Bridge Factors Factual Report Attachment 24 – Email from Mr. Rodrigo Isaza of MCM to Mr. Dwight Dempsey of FIGG dated March 12, 2018

Miami, FL

HWY18MH009

Subject: RE: FIU-UCPP - Stage 3 - Erection of Main Span

PHOTO 1: Diaphragm 2, Westside top view, crack

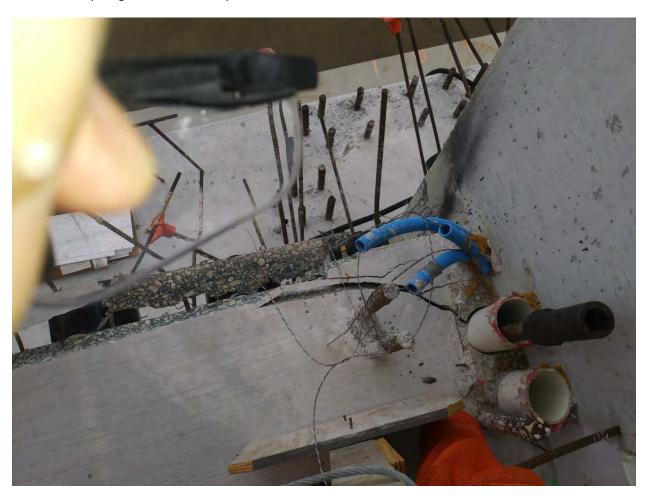
Following our previous emails regarding the noted cracks, and as witnessed on site by FIGG as part of the movement/erection support, attached please find photos depicting the cracks developed prior and post the span 1 erection and/or distressing of truss members 2 & 11 (your team may have most of these pictures). It is our opinion that some of these cracks are rather large and/or of concern; therefore, please review and comment as promptly as possible and advise if there is a required course of action to remedy or address these right away.
